## SCS ENGINEERS

Subject: Response to RAI No. 2  
Citrus County Central Class I Landfill  
7-Acre Re-Closure Construction Certification  
Permit No. 21375-014-SF/01, Citrus County  
WACS No.: SWD/09/39859

NOT TO SCALE

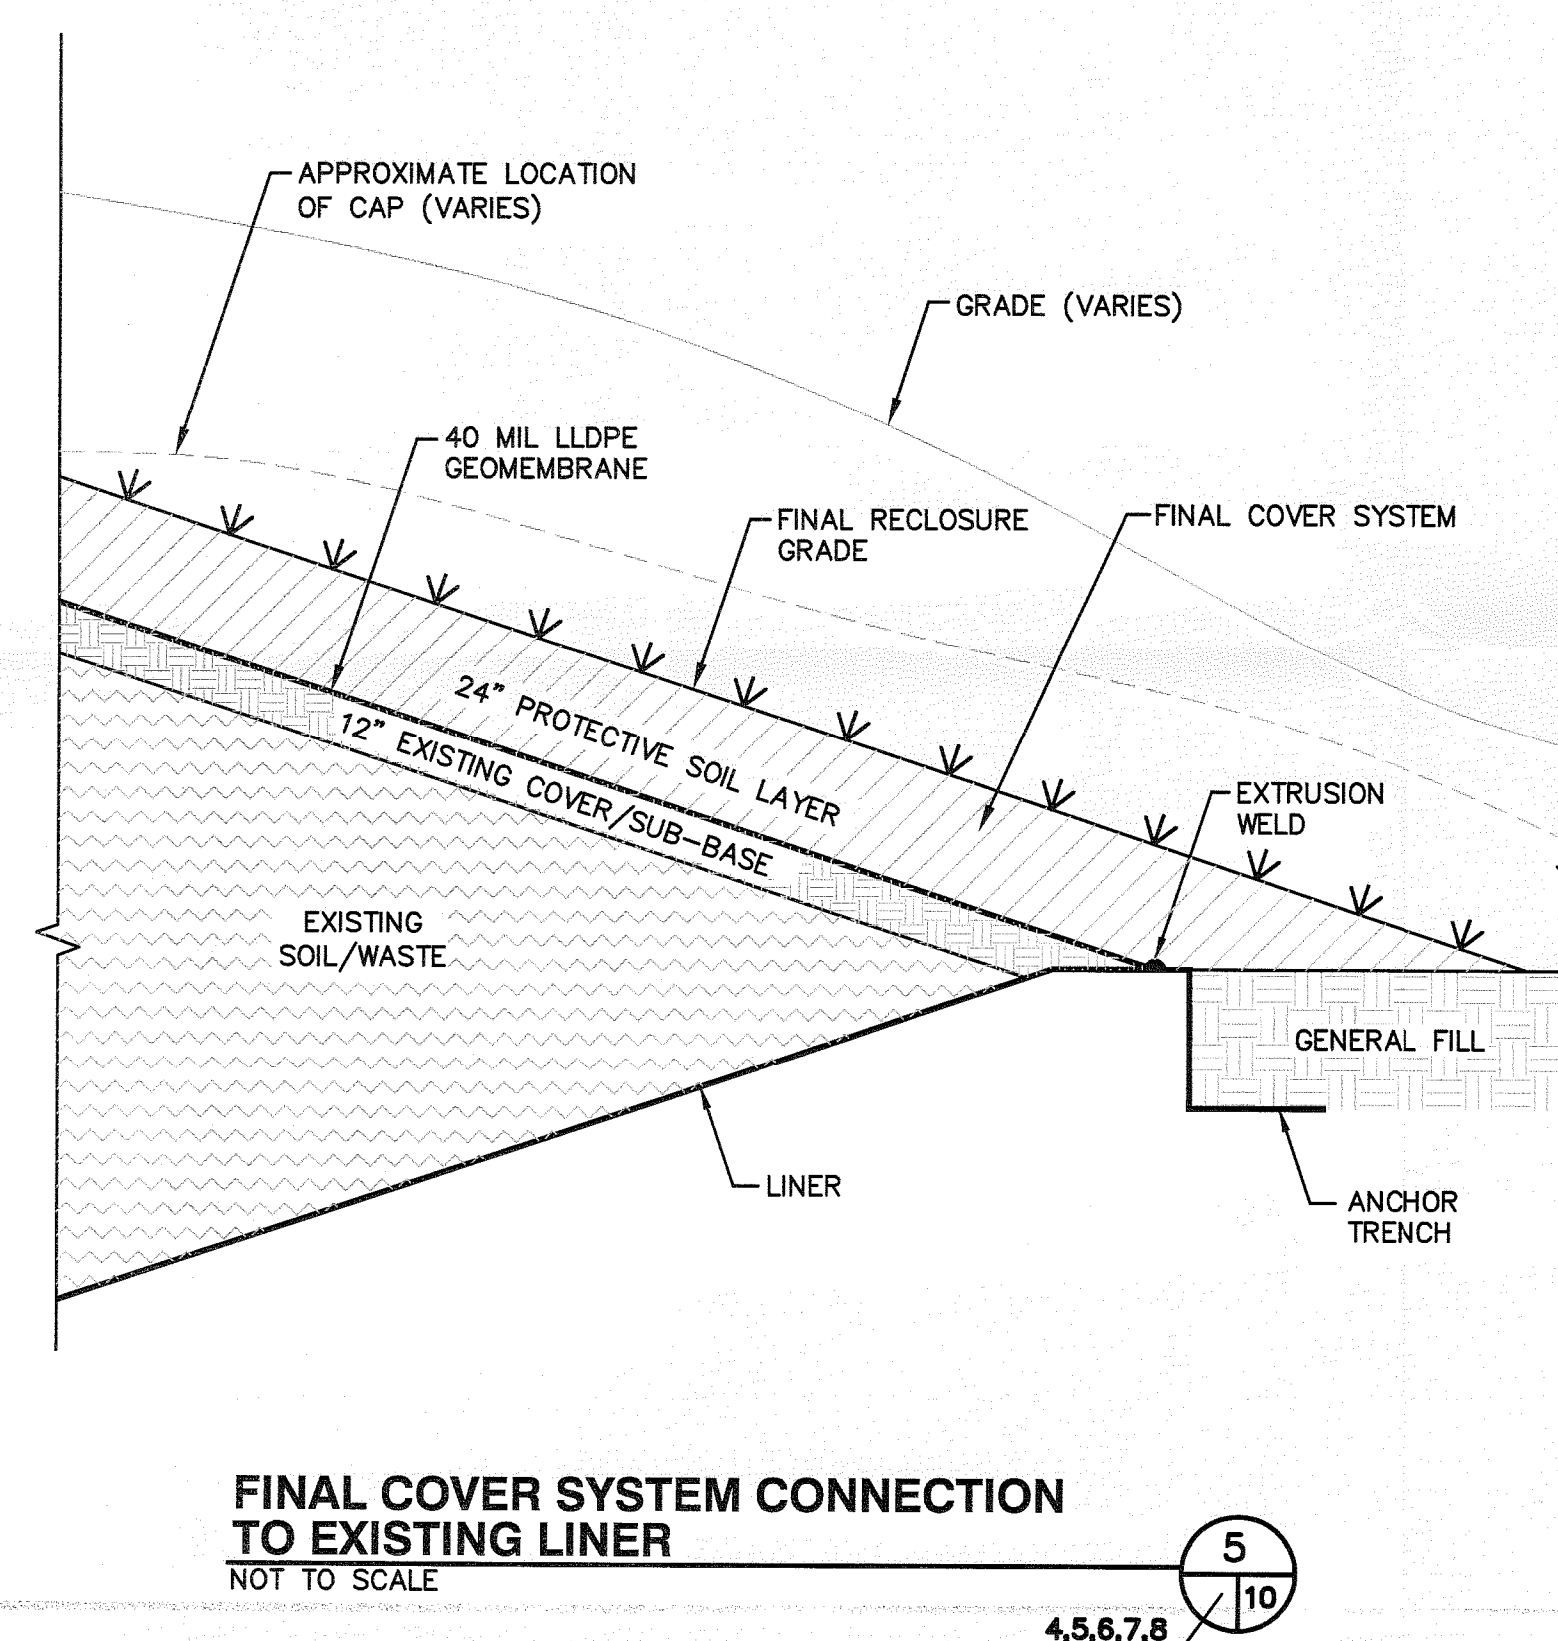
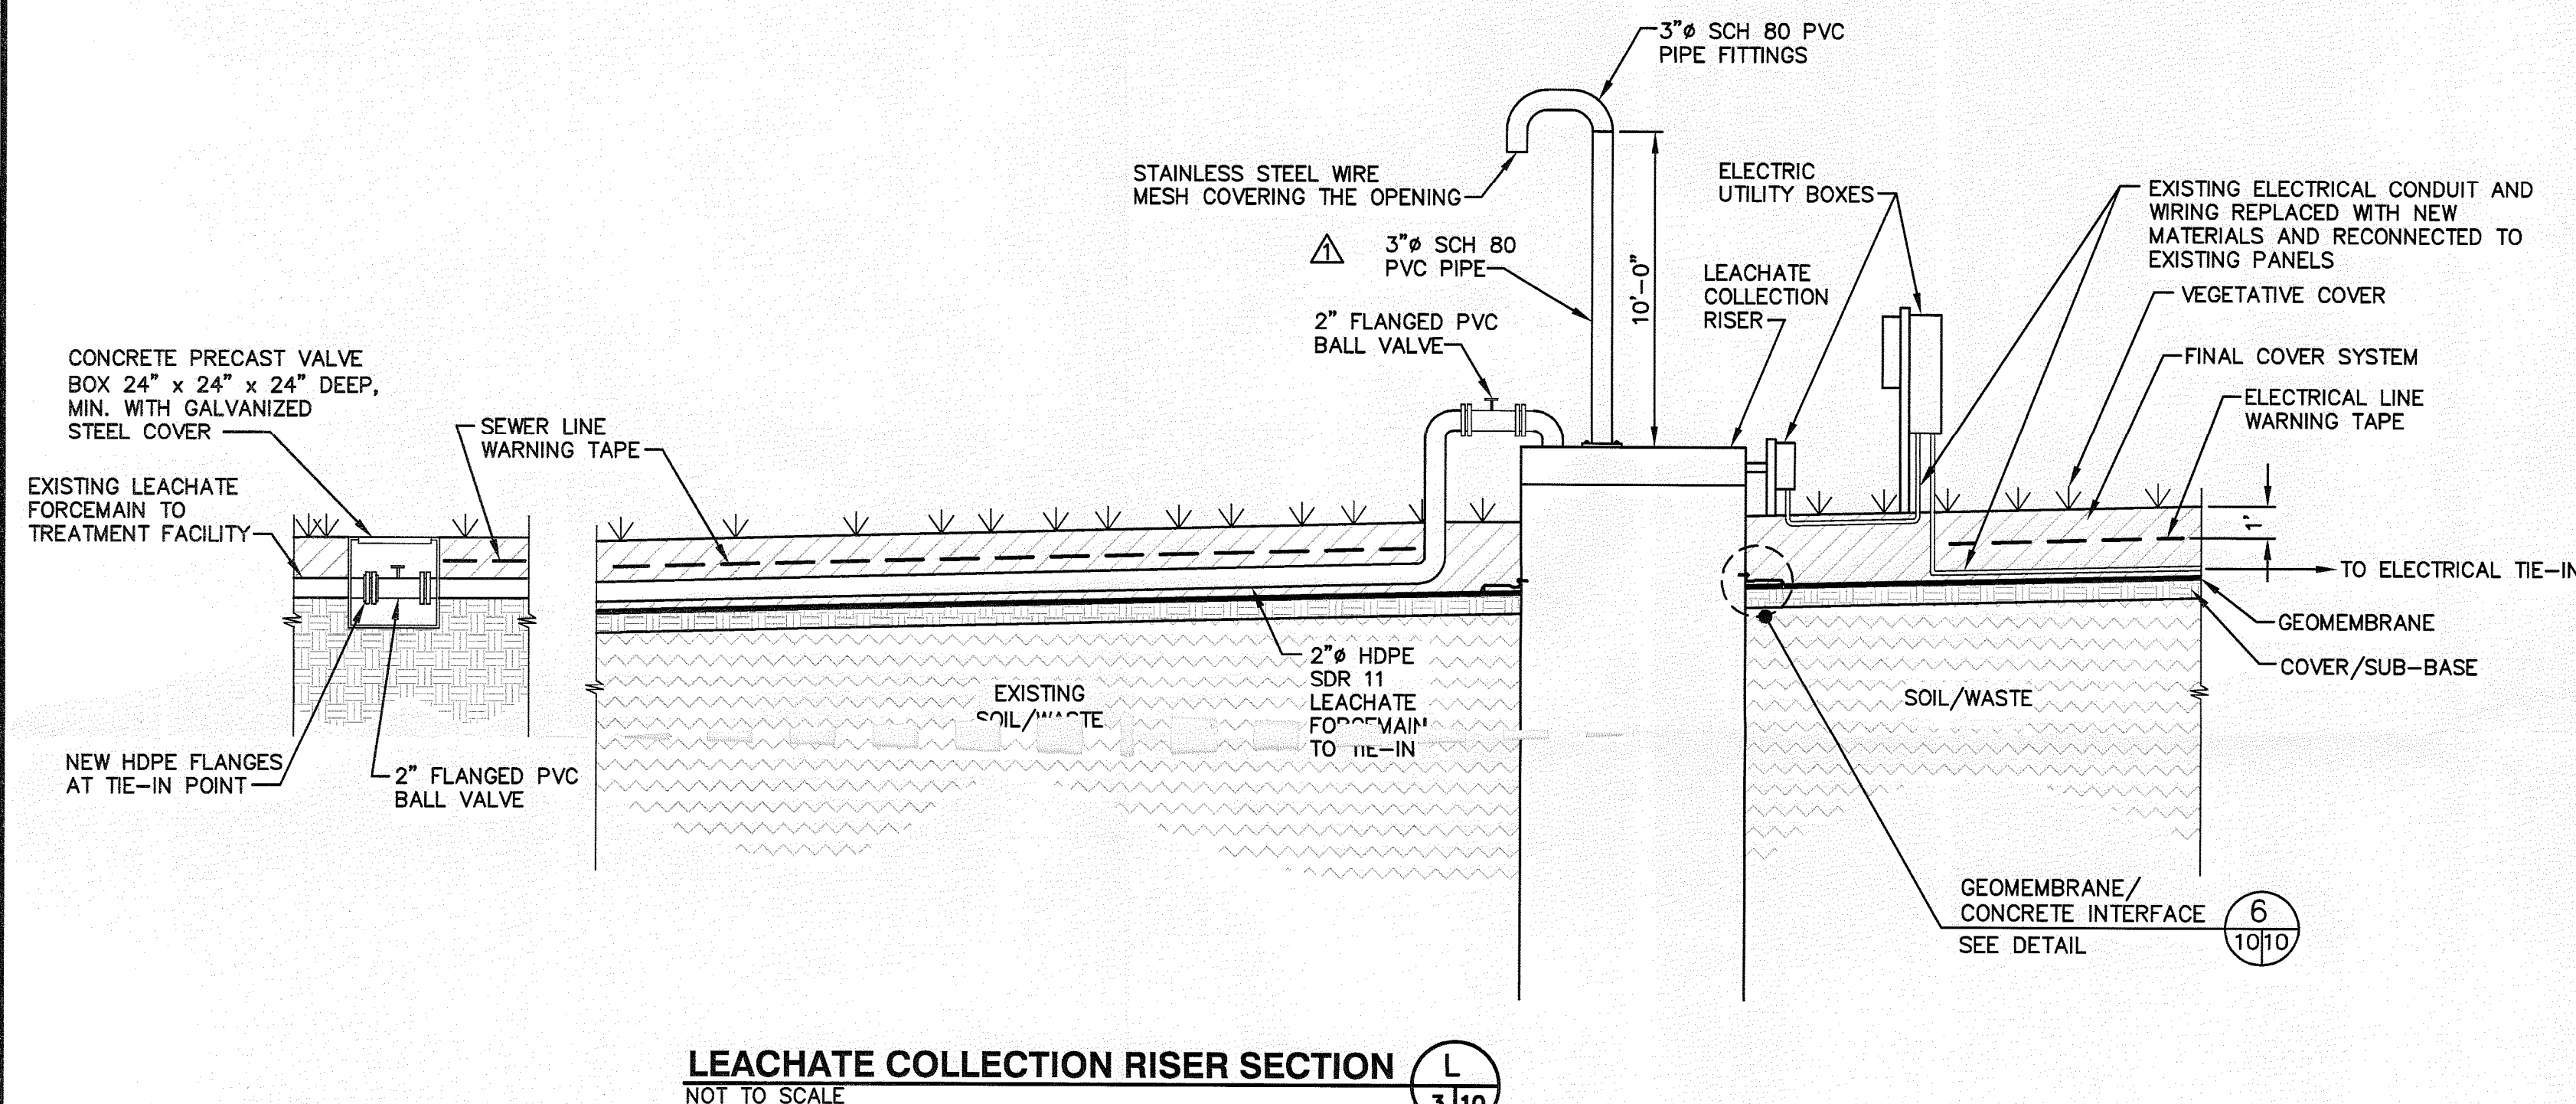
a. **Vent Schedule:** The reported slotted pipe length of 11 ft. for gas vent GV-6 appears inconsistent with the boring log on the vent construction log for GV-6 in Appendix C, which appears to indicate that the slotted pipe is installed approximately from 19 ft to 34 ft below ground surface. Please verify and revise this sheet and/or the vent construction log, as appropriate.

**Response:** Attachment 1 contains a new Sheet 10 in which the correct well depths, solid and slotted pipe lengths are given and noted. Attachment 3 contains a revised boring log for GV-6 in which the 11 feet of slotted pipe has been increased to 15 to indicate the appropriate amount of installed pipe.

Well Number: GV-02  
 Coordinates:  
 Surface Elevation: 124.00  
 Top of Casing Elevation: 131.00

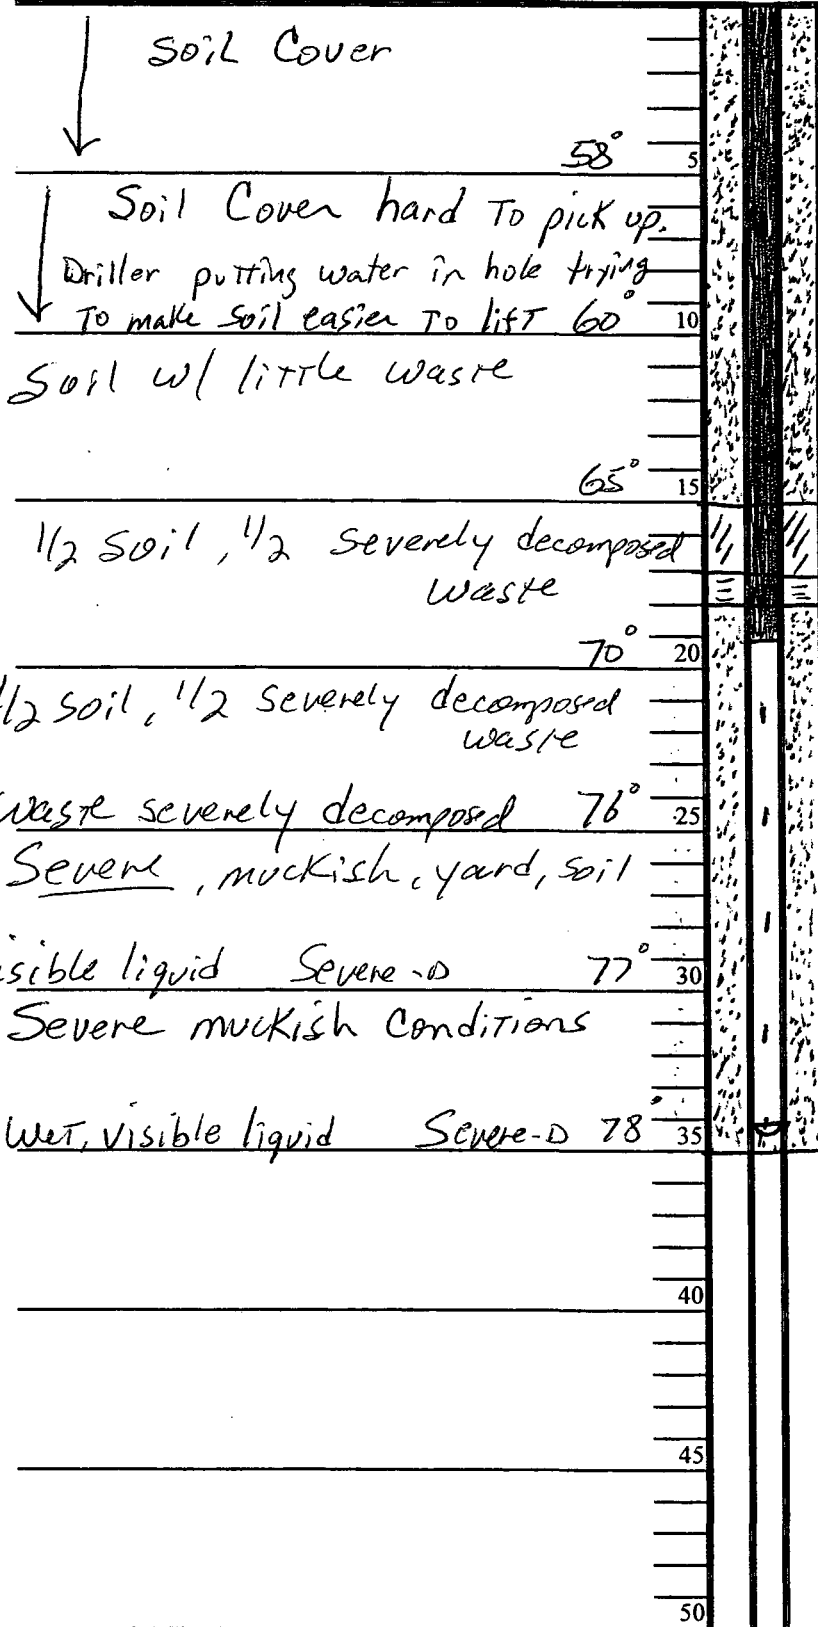
a. The February 9, 2011 response letter refers to the shortening of the three gas vents (GV-2, GV-3, and GV-6) "by approximately 7 ft each". The Vent Schedule indicates that these vents were shortened by 14 ft, 14 ft, and 19 ft respectively. Please verify and explain this discrepancy.

Response: Gas vents GV-2 and GV-3 and GV-6 were all drilled to 35 feet as indicated on the well logs submitted with the original Report of Construction dated August 31, 2010. All the gas vents were originally designed to be 50 feet deep with 49 feet of perforated and solid pipe below grade. Of the pipe below grade 19 feet was

The 14 ft., 14 ft. and 19 ft. referred to in this request are the lengths by which the slotted pipe was shortened from the original design not considering the new revised design depths. Considering the new design depths the slotted pipe lengths were shortened by 7 feet for GV-1, 0 ft for GV-3 (solid pipe shortened by 6 feet) and 6 feet for GV-6.

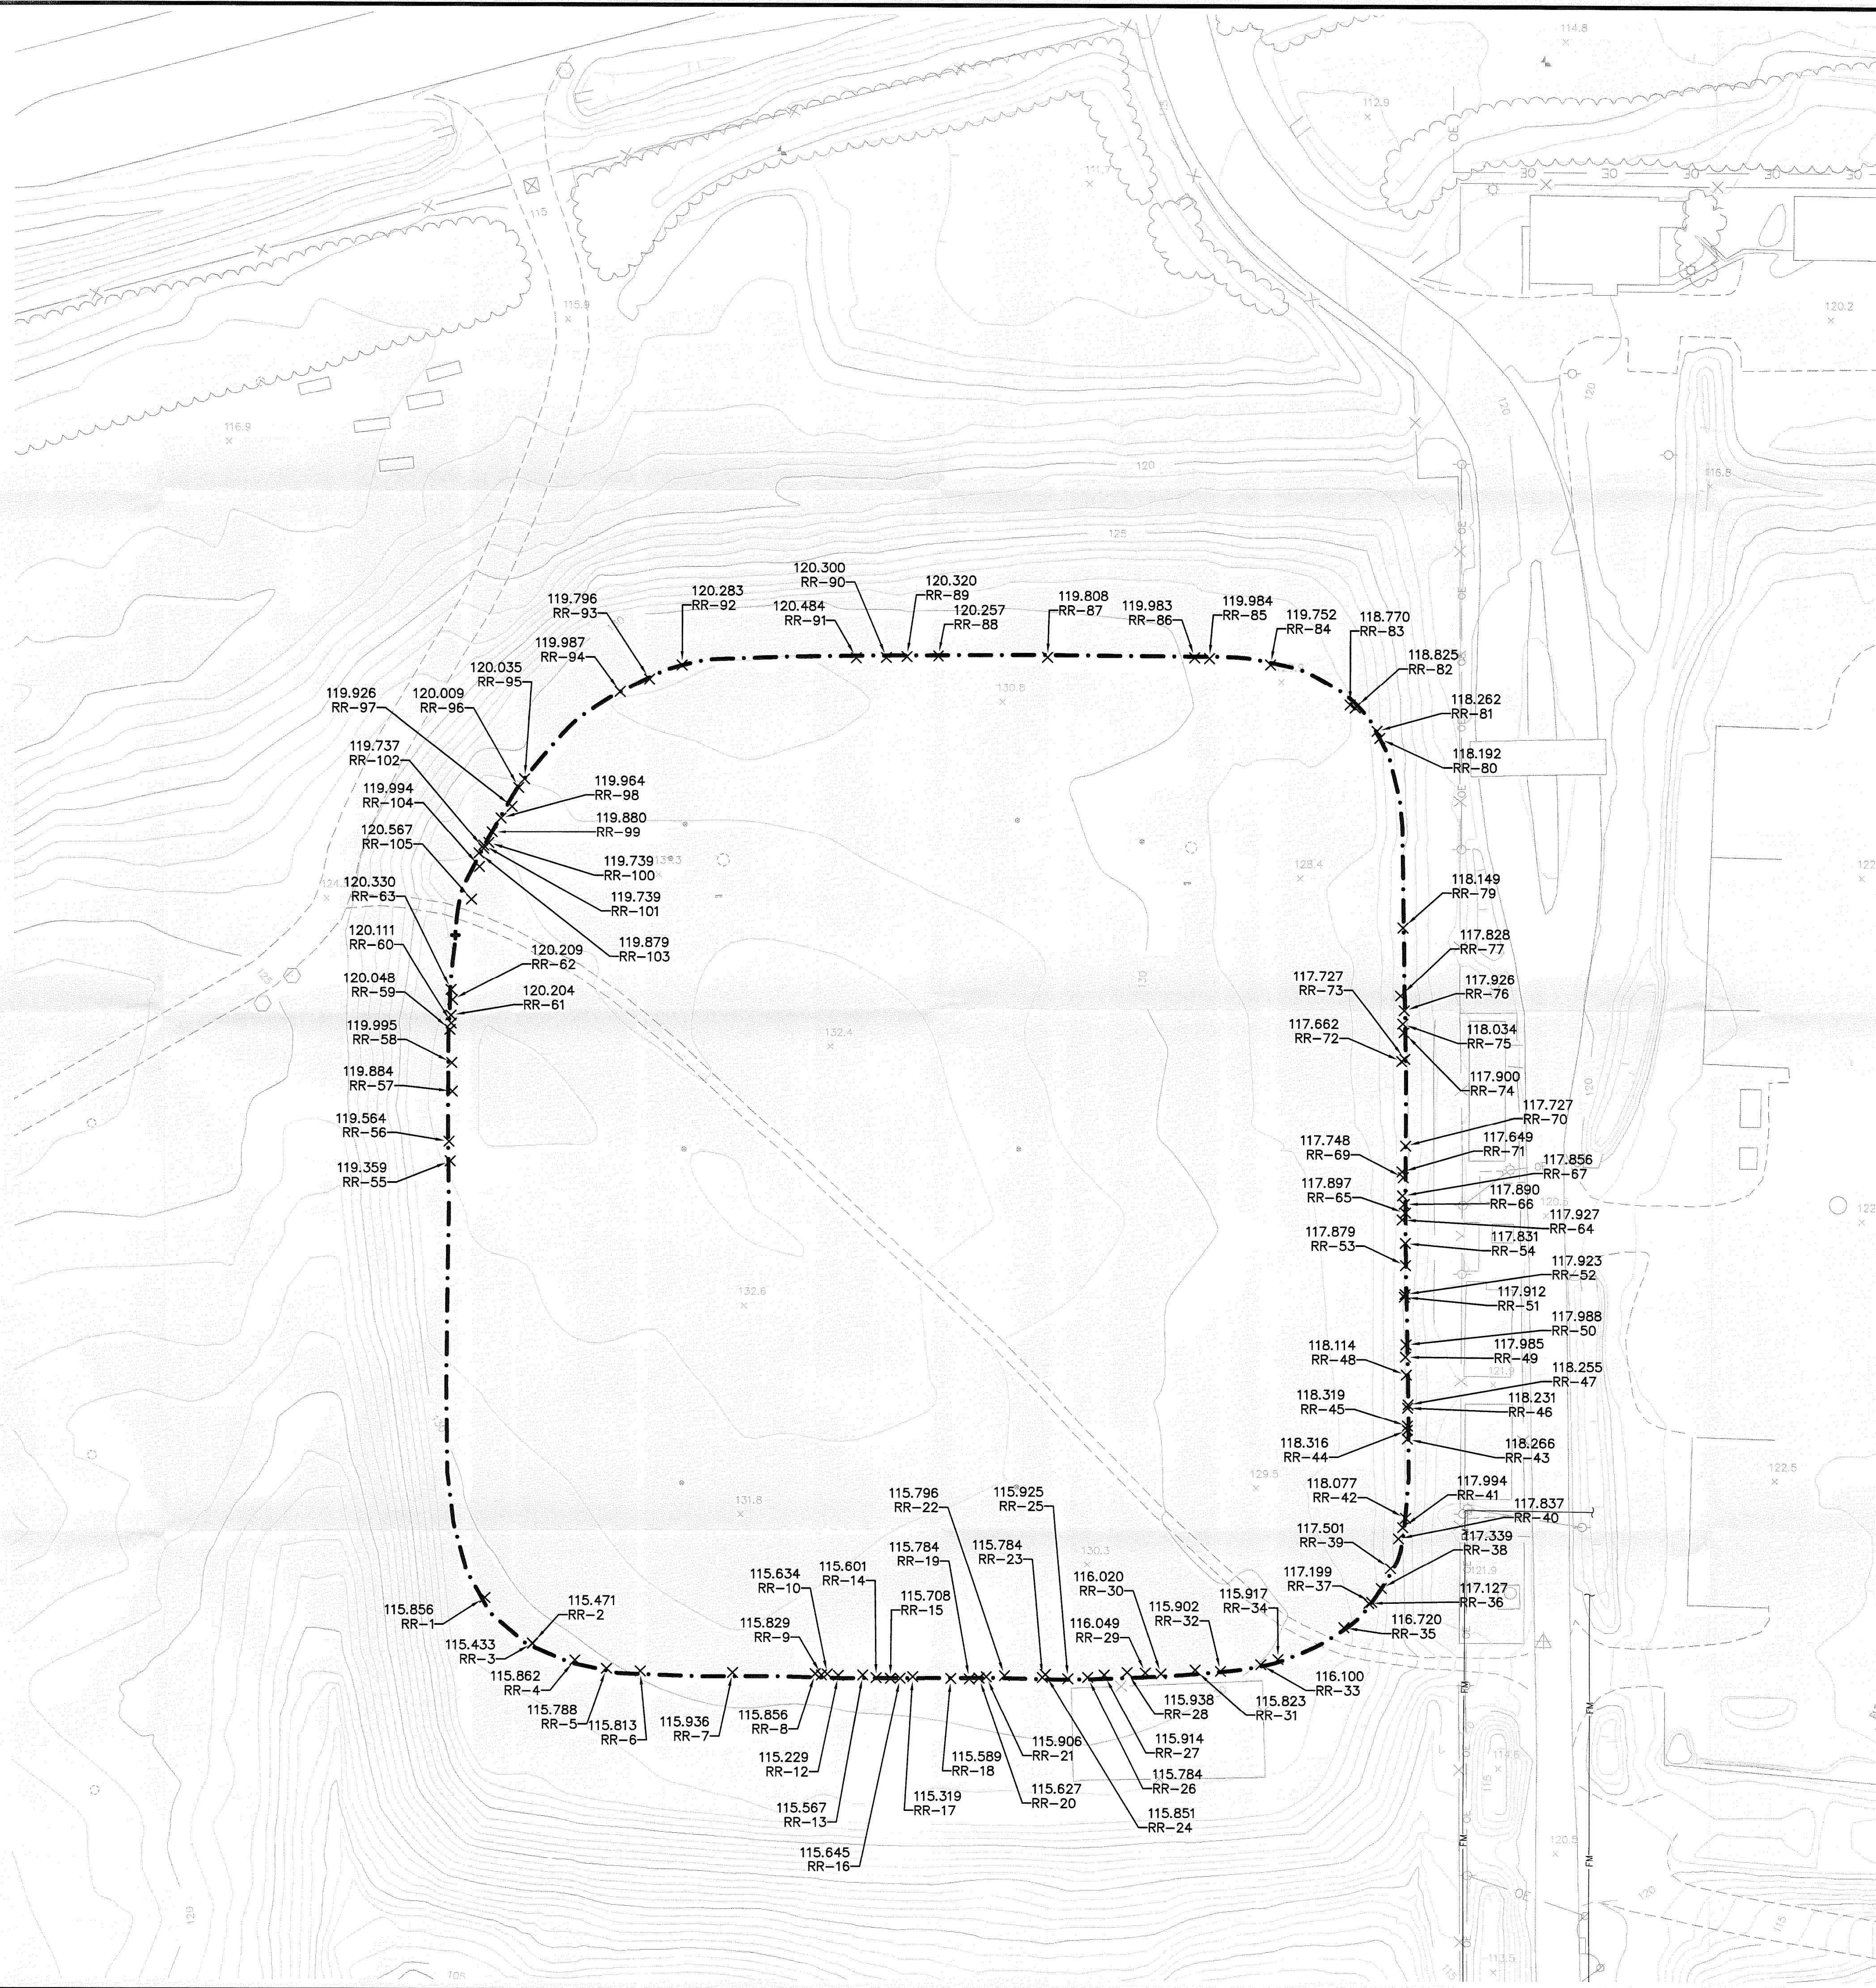
7. The existing liner Repair Numbers and locations on the figure provided in Attachment 3A are not legible. Please provide a revised figure of sufficient size and scale to allow identification of the repair designations on the figure.

8. Repair RR-1 and RR-2 are shown on the bottom liner in the interior of the landfill (i.e., beneath the existing waste). Please verify the location of these repairs reported in the log and revise the figure and/or the location of the repairs reported in the repair log, as appropriate.

**Response:** Attachment 6 Contains a revised Existing liner repair drawing more clearly indicating the location of the Repairs. The Existing repair log submitted as Attachment A-3 of the February 9, response does correctly indicate the northing and easting of the repairs as well.

**Response:** The points RRR-1 and RRR-2 indicated on the interior of the liner are not repair locations and have been deleted from the drawing in Attachment 6. They were reference points used for internal purposes only.
